## SHAKER HEIGHTS

### Landmark Commission Agenda Via Conference - Zoom Wednesday, January 28, 2026, 7:00 p.m.

## Memorandum

Re: **Certificate of Appropriateness: 18716 Scottsdale Boulevard—Proposed Roof Replacement.** Reece Berry and Matthew Miller, property owners.

**Proposed Asphalt Shingle in Shenandoah**

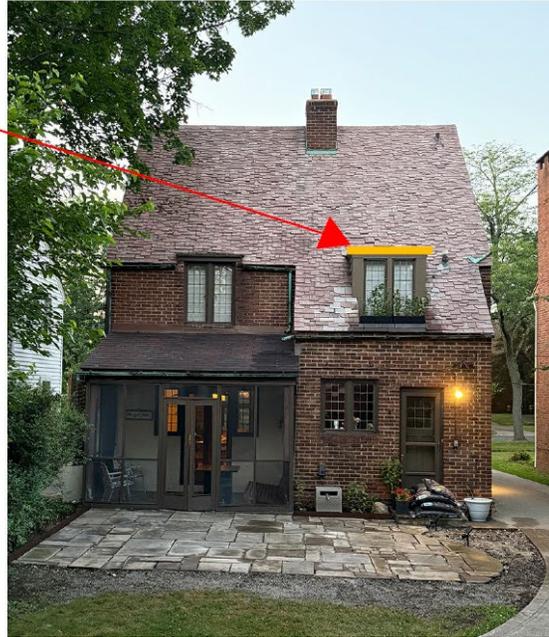
The homeowners are proposing to replace the existing asbestos shingle roof with new asphalt, Certainteed Landmark Pro Max Def shingles in Shenandoah. The homeowners will ensure that installation methods and accessory materials remain consistent with the character of the house. All roofing work will be performed by Renegade Roofing, an experienced contractor familiar with residential construction. The shingles will be installed using standard best-practice methods in accordance with manufacturer specifications.

1. The style and color of the asphalt shingle should follow the Landmark Commission's preference in a darker brown color range.
2. If the new gutter is not copper, it should be half round aluminum hung the same way as the existing gutters, in a brown finish to match the existing copper gutters.
